**APPLICATION TO THE RESIDENTIAL DESIGN
AND COMPATIBILITY COMMISSION (RDCC)**

GENERAL MODIFICATION WAIVER

STREET ADDRESS: 2803 CREST

City of Austin Residential Permit Application Master Comment Report

SITE PLAN

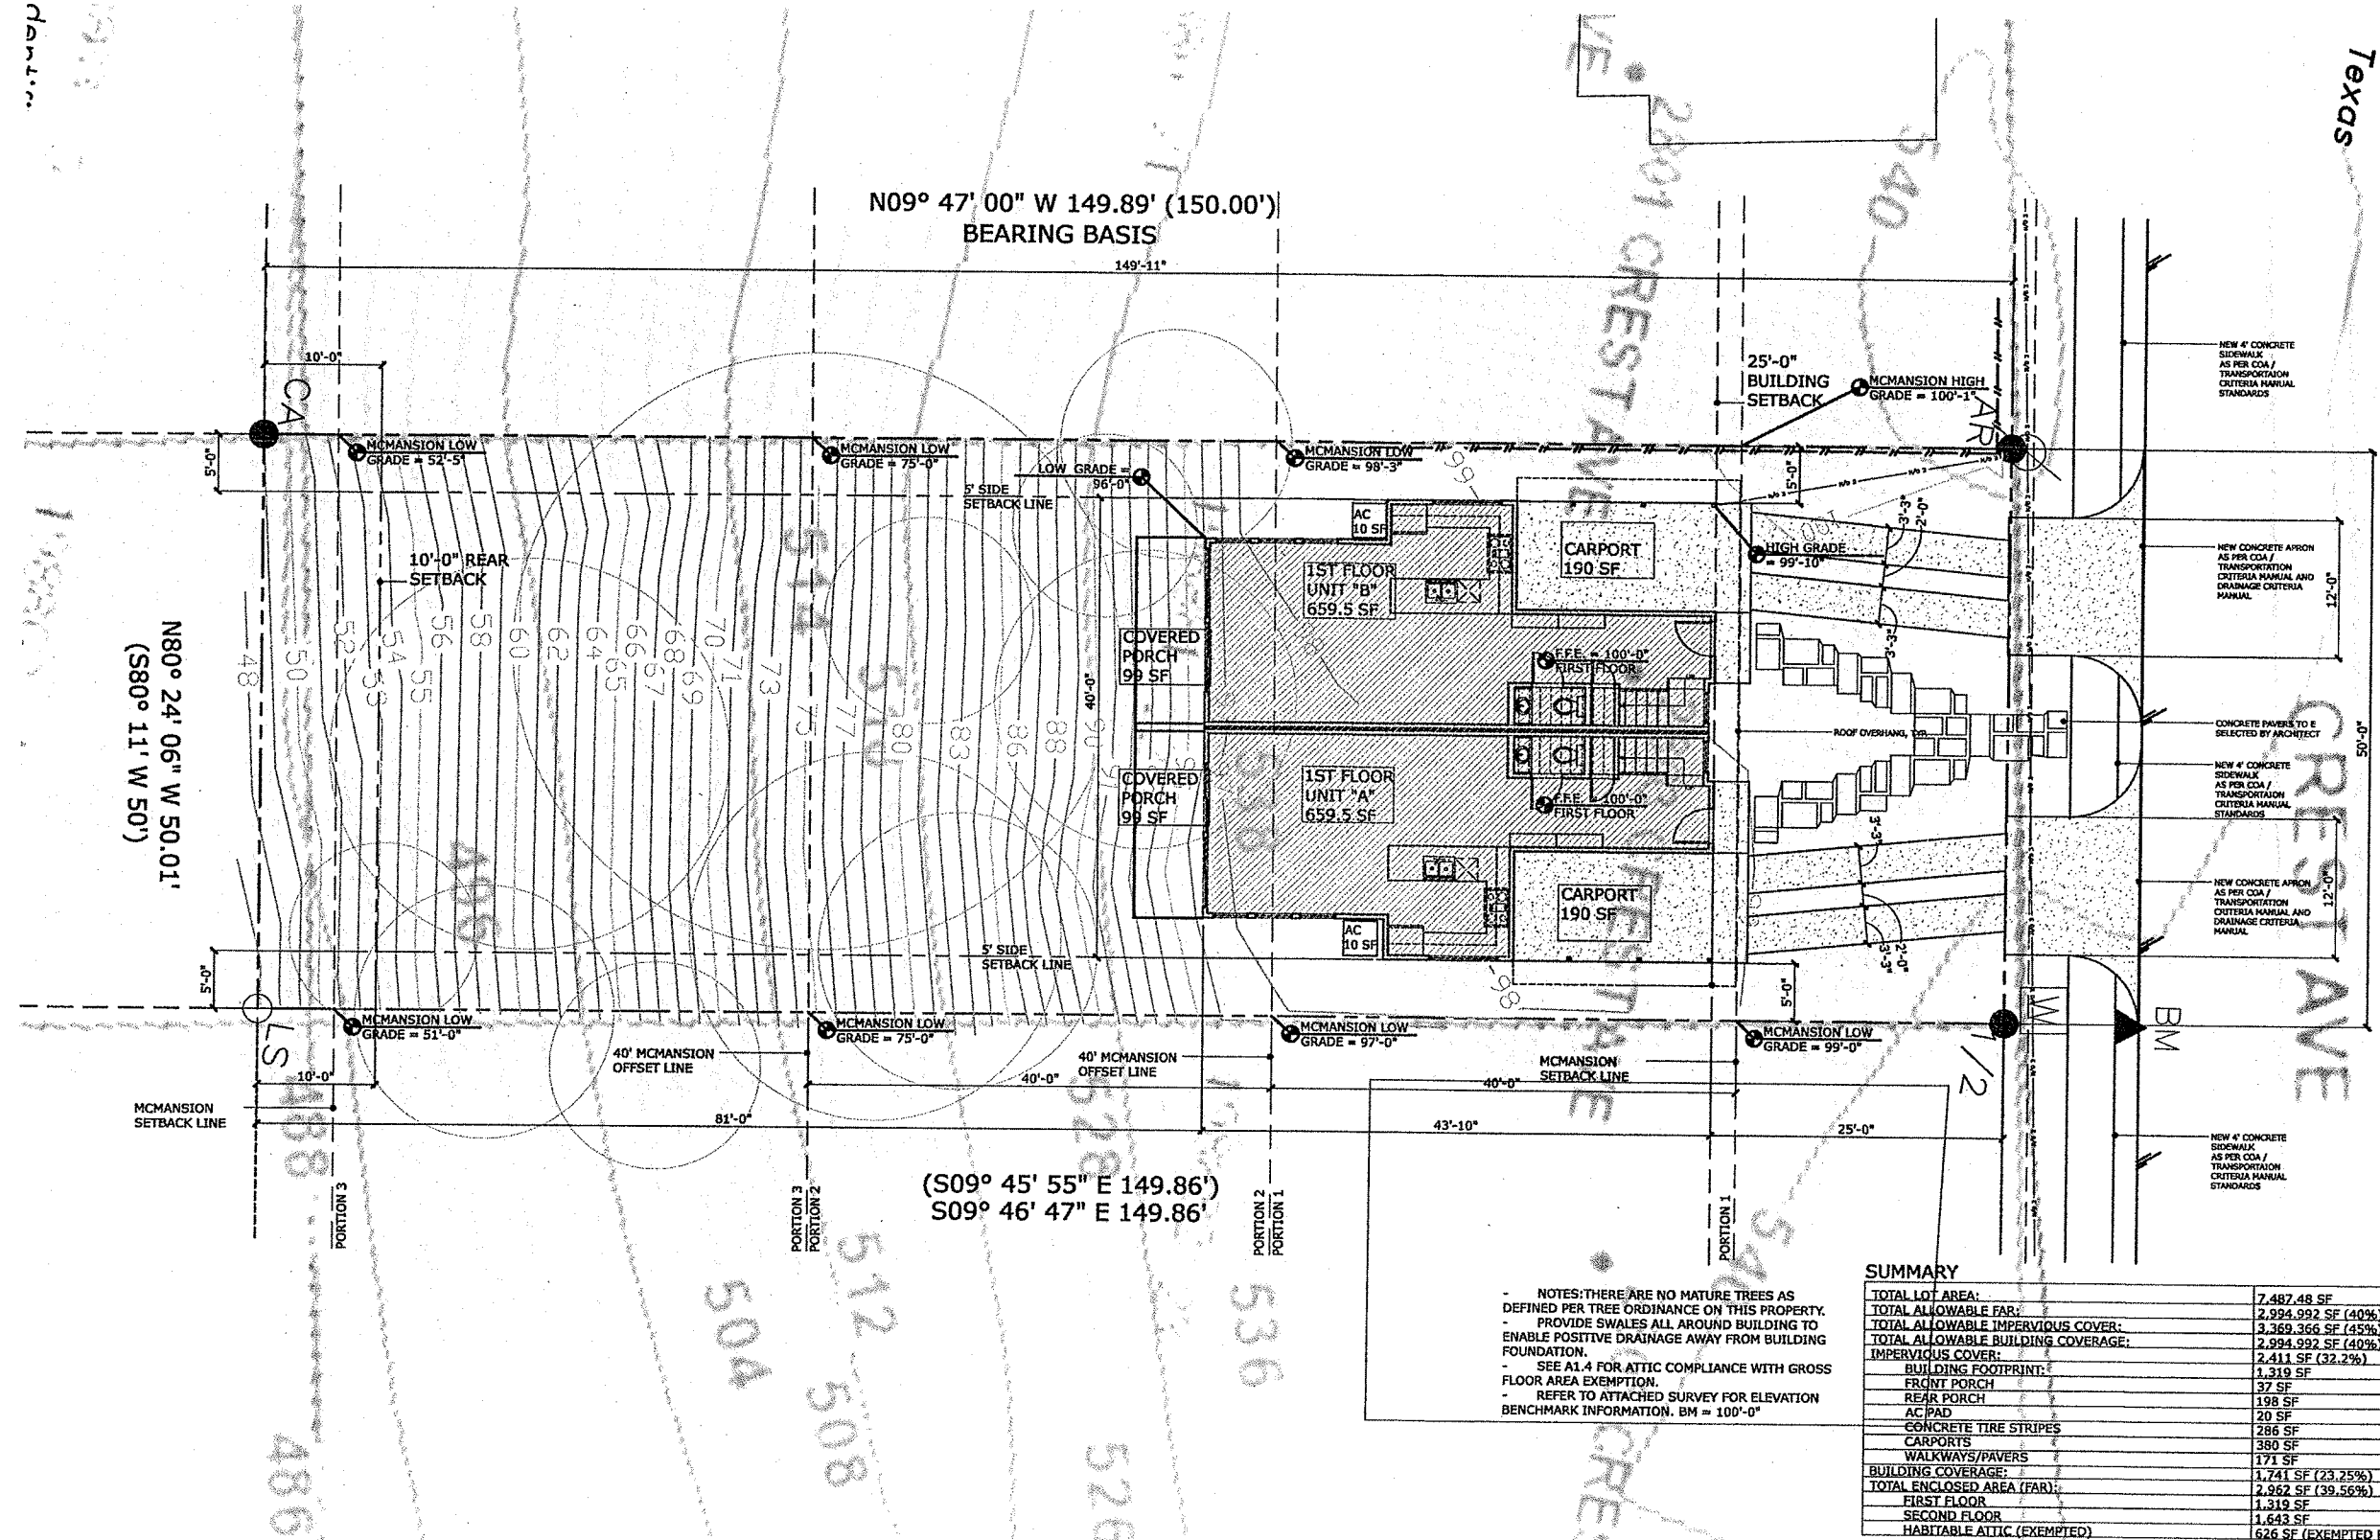
1. A total demolition permit for the existing structure at this site will be required prior to approval of this Plan Review. You need to contact or visit Michael Watson (2nd Floor/walk-in hours M,W, or F from 8a to 11a) to submit for a total demolition permit.
2. Add the Benchmark's spot elevation on the plot plan. You have labeled a "BM" but have not provided the spot elevation value.
3. As submitted, you have two attached garages because both parking areas only have one open side. In order to get a 450sf exemption for a carport per Sub-Chapter F – the carport must be open on at least two sides and the open sides are clear and unobstructed for at least 80% of the area measured below the wall plate to the finished floor to the carport. As submitted, at least one of the garages

will have to meet these criteria. Revise plans accordingly because as submitted, you only have a valid 200sf exemption available and are exceeding the .40 maximum FAR.
